## 63 Marine Parade, Avalon

### Geotechnical Comments for Section 4.55

We have reviewed the existing geotechnical report, the original plans, the previous Section 4.55 Letter, and the 5 amended plans by ShimDesign, drawings numbered DWG 0319 1/5 to DWG 0319 5/5, Revision E, dated 10/9/23.

We have reviewed the existing geotechnical report, the original plans, and the amended plans by Shimdesign numbered 0514-1/5, dated 10/12/14, and 0319-2/5 to 5/5, dated 10/12/19.

SITE PLAN – showing additional test locations

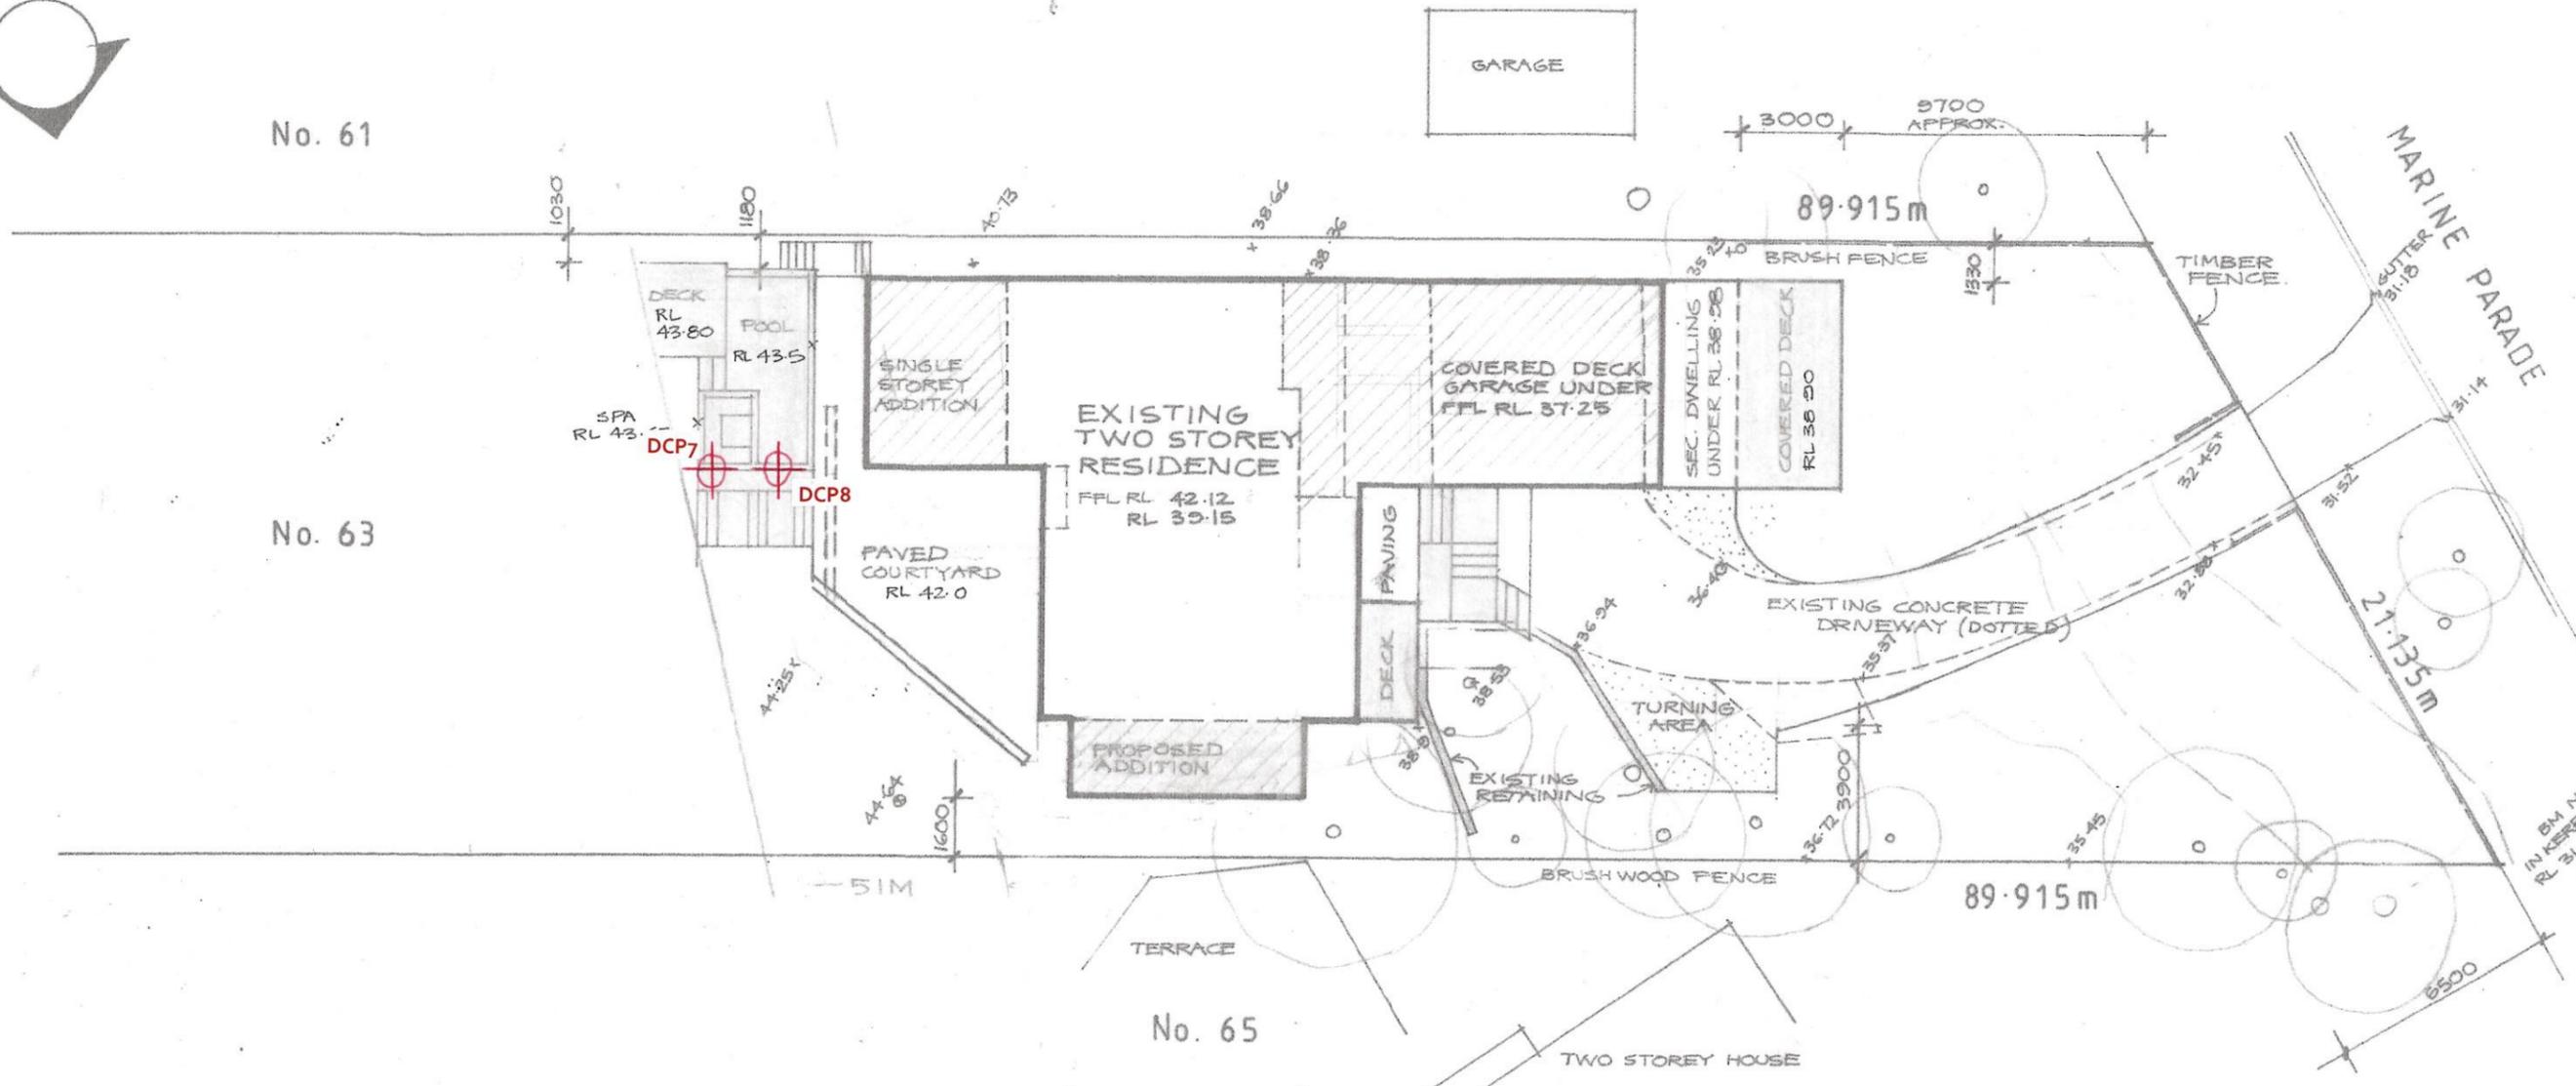
Two additional Dynamic Cone Penetrometer (DCP) tests were put down to determine the relative density of the overlying soil and the depth to bedrock in the location of the proposed pool. The locations of the tests are shown on the site plan below.

The vibrations from the proposed excavation are a potential hazard (**Hazard One**). The excavation for the proposed pool is a potential hazard until the retaining walls are in place (**Hazard Two**).

During the excavation process, the geotechnical consultant is to inspect the cut in 1.5m intervals as it is lowered, while the machine/excavation equipment is on site, to ensure the ground materials are as expected and no additional temporary support is required.

Excavation methods are to be used that limit peak particle velocity to 10mm/sec at the supporting walls of the subject house and property boundaries. Vibration monitoring will be required to verify this is achieved.
